January 24, 1992  
LD-92-006

Docket No. 52-002

Subject: Response to NRC Requests for Additional Information

RESPONSE TO NRC REQUESTS FOR ADDITIONAL INFORMATION  
PLANT SYSTEMS BRANCH

Figure  
9.2.2-1

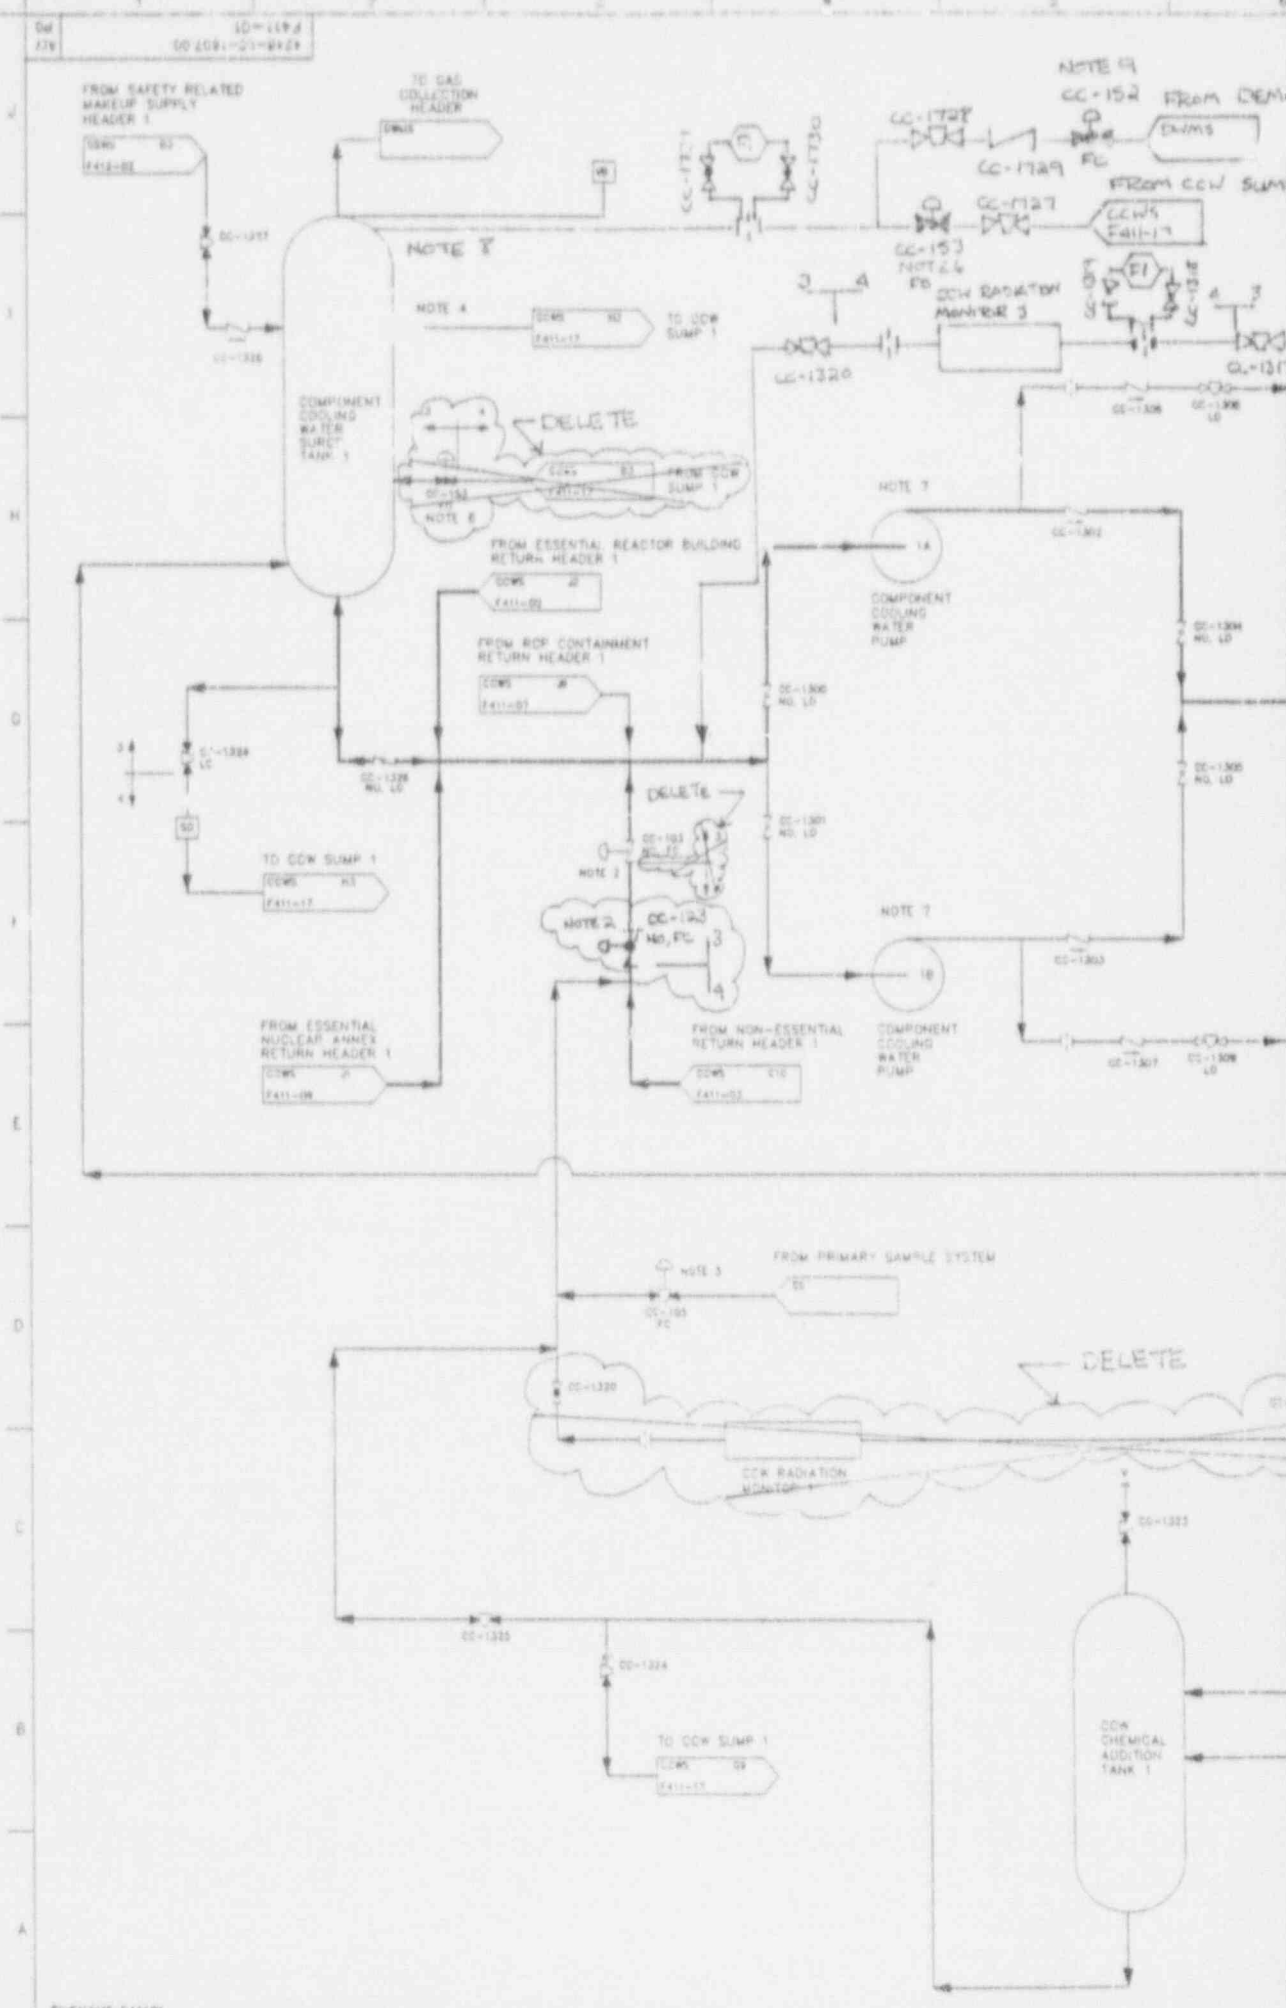
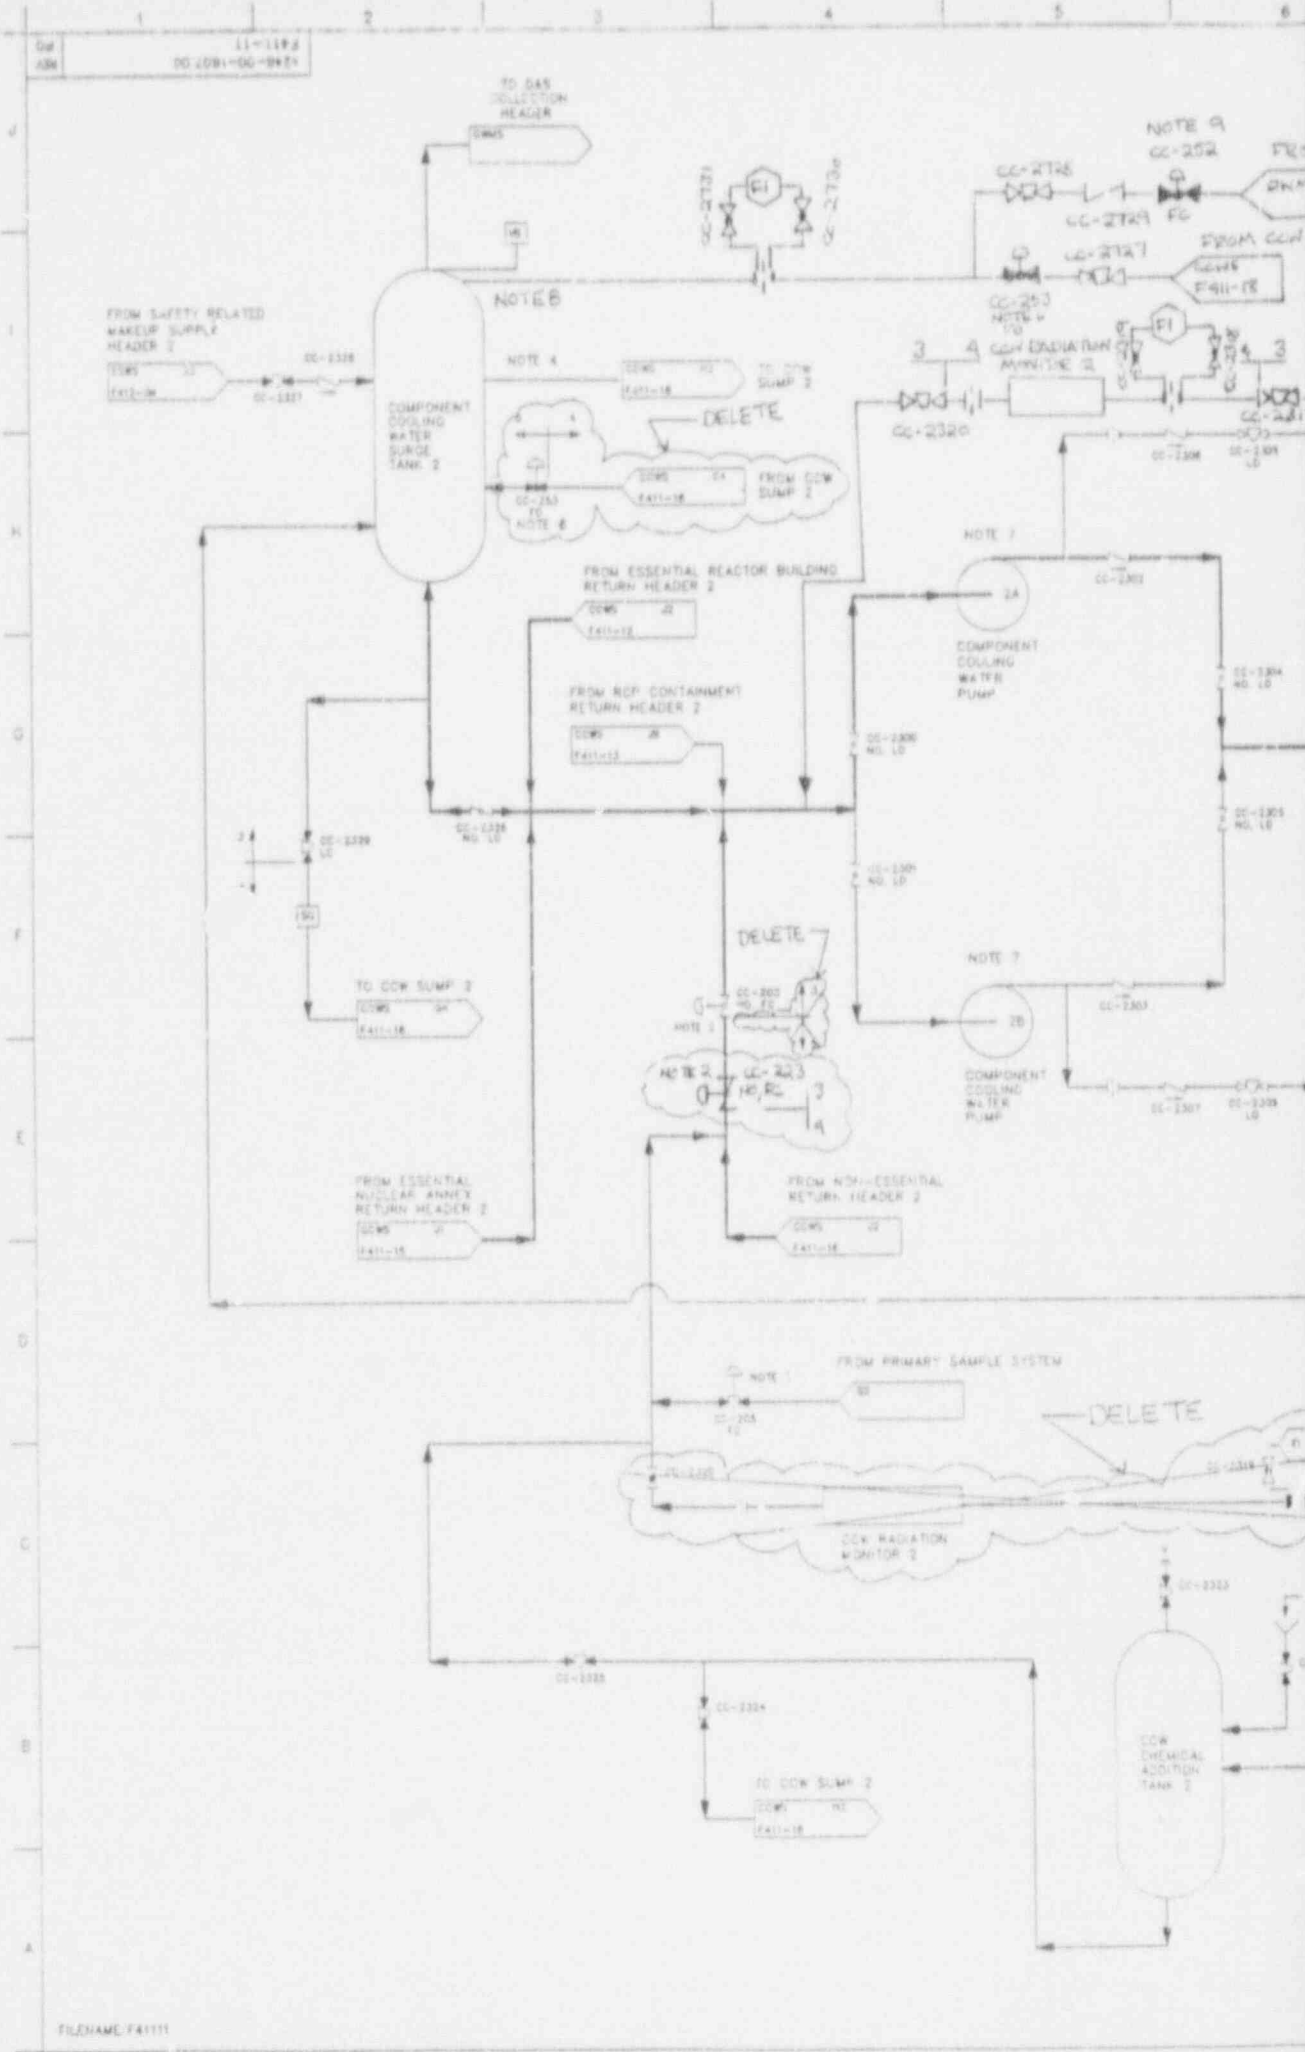
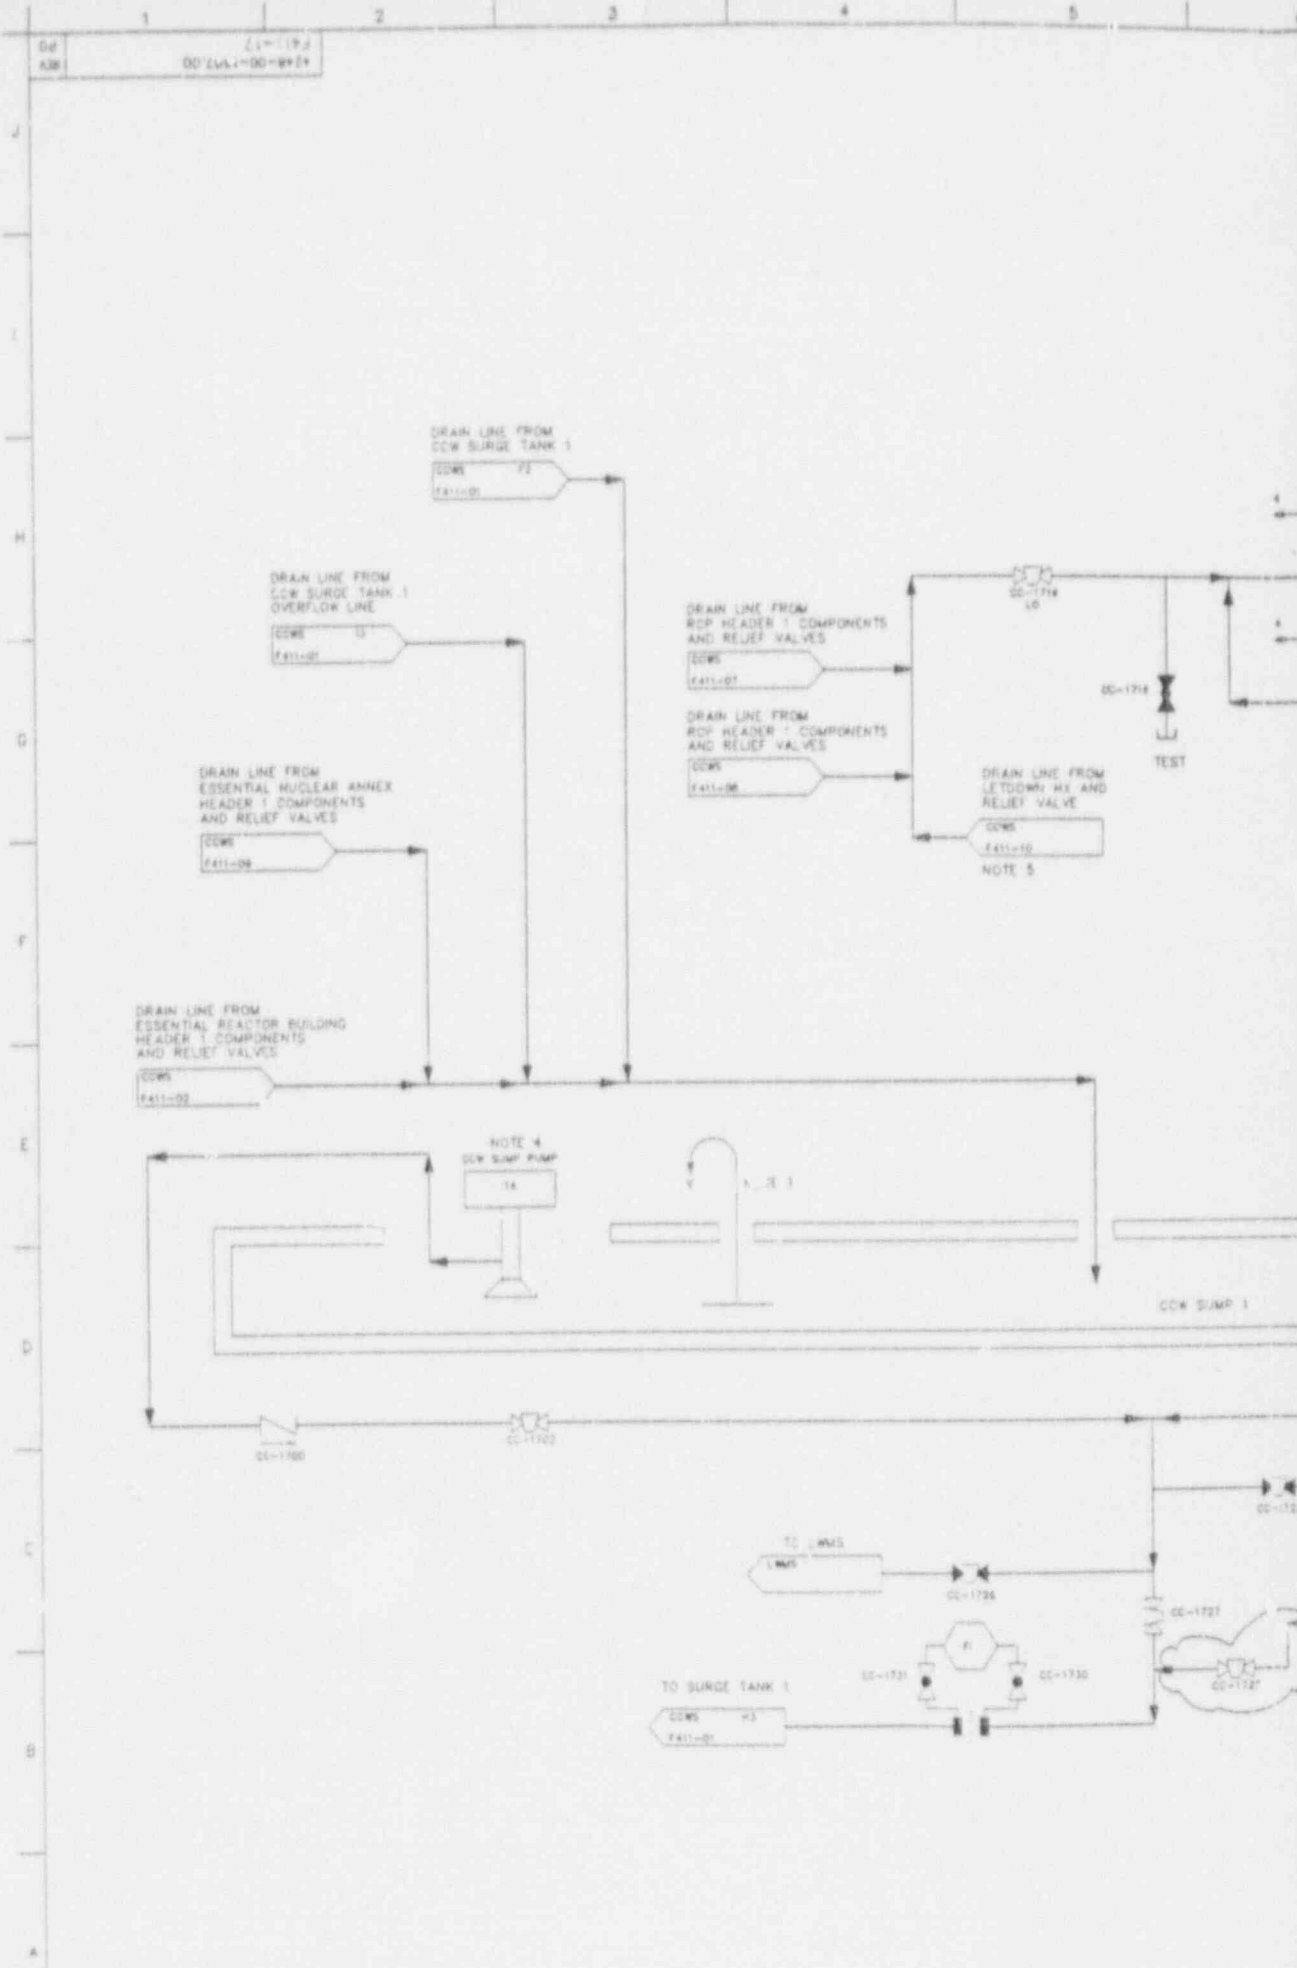
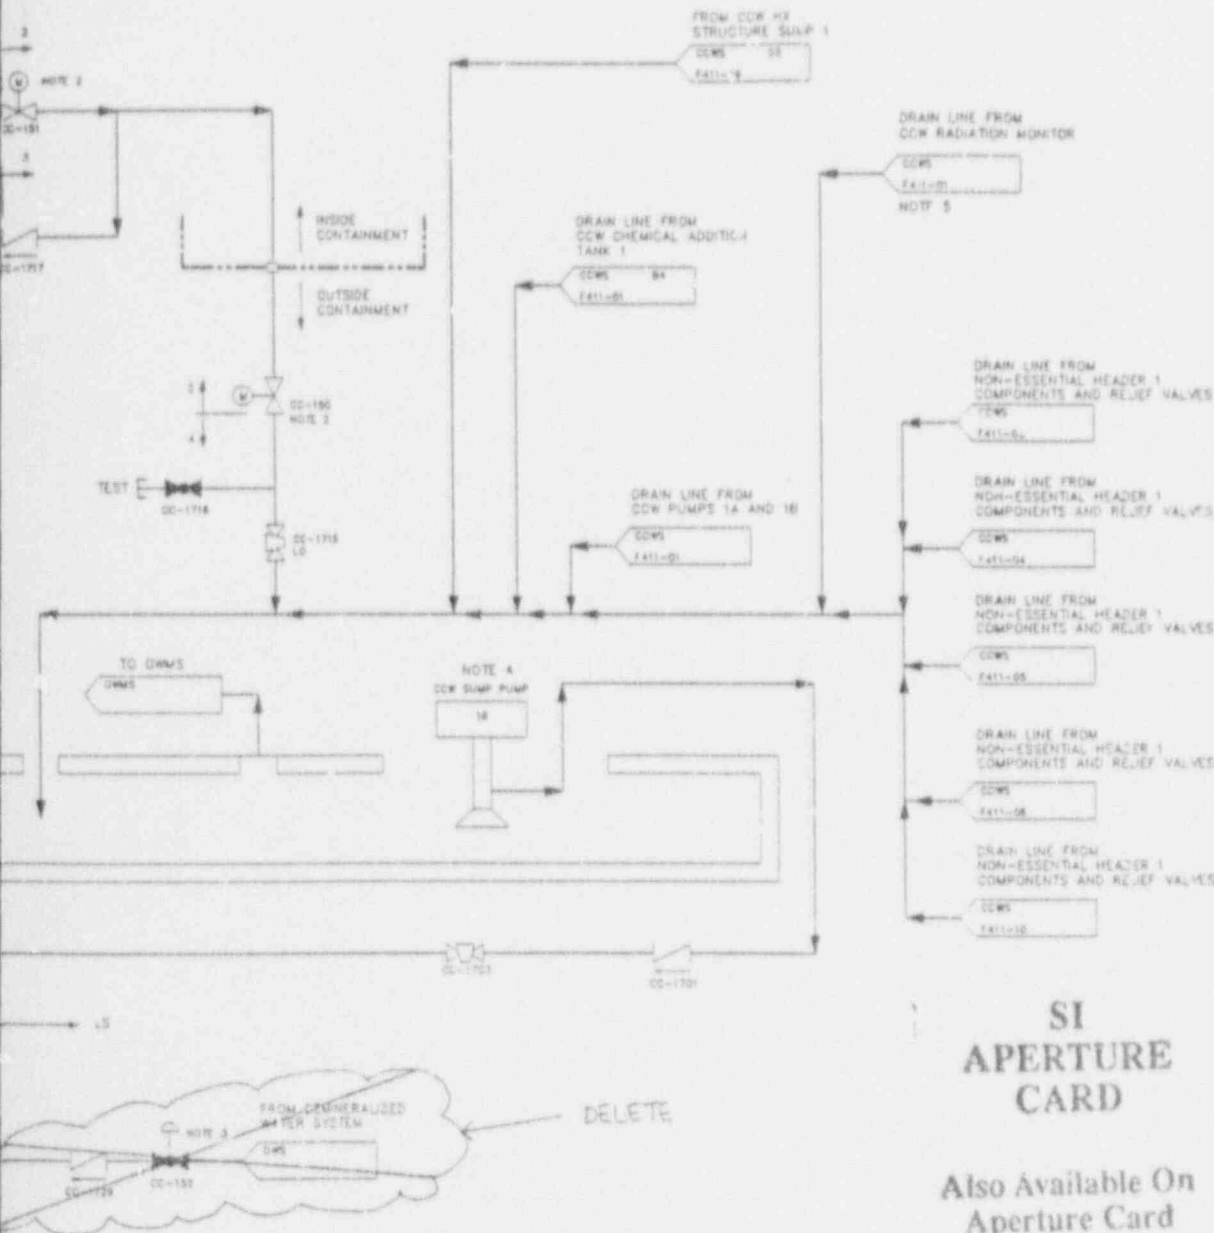
- e. Table 9.2.2-4 should be revised to identify the design volume of the surge tanks to allow for an evaluation of the adequacy of this volume.
- f. Figure 9.2.2-1 should also be revised to identify the interface between the CCWS and the Demineralized Water System. While the Demineralized Water system is the primary makeup system, it is not reflected on the CESSAR figures.

This response is being incorporated into CESSAR-DC Section 9.2.2, "Component Cooling Water System." The line is being moved to a higher point on the surge tanks on Sheet 1 and Sheet 11 of Figure 9.2.2-1 to better reflect its relative position. Also, this response is reflected as a note addition on Sheet 1 and Sheet 11 of Figure 9.2.2-1. Markups of Sheet 1 and Sheet 11 of Figure 9.2.2-1 are attached for NRC review.

- f. The Demineralized Water Makeup System (DWMS) makeup to the Component Cooling Water Surge tanks is reflected on Sheet 17 and Sheet 18 of Figure 9.2.2-1. The line for DWMS makeup to the CCWS is being moved to Sheet 1 and Sheet 11 of Figure 9.2.2-1 to better reflect normal makeup to the surge tanks.

This response is being incorporated into CESSAR-DC Section 9.2.2, "Component Cooling Water System." The response is reflected as the removal of the DWMS connection from Sheet 17 and Sheet 18 and the addition of the DWMS connection on Sheet 1 and Sheet 11, respectively. Markups of Sheet 1, Sheet 11, Sheet 17, and Sheet 18 are provided for NRC review.

This response is being incorporated into CESSAR-DC Section 9.2.2, "Component Cooling Water System." The radiation monitors are being relocated to allow their use during all modes of system operation (See Sheet 1 and Sheet 11 of Figure 9.2.2-1). Section 9.2.2.2.1.7, "Component Cooling Water Radiation Monitors," and Section 9.2.2.5.5, "Radiation Monitors," are also being revised to reflect this change. Markups of Figure 9.2.2-1 (Sheet 1 and Sheet 11) and Sections 9.2.2.2.1.7 and 9.2.2.5.5 are provided for NRC review.
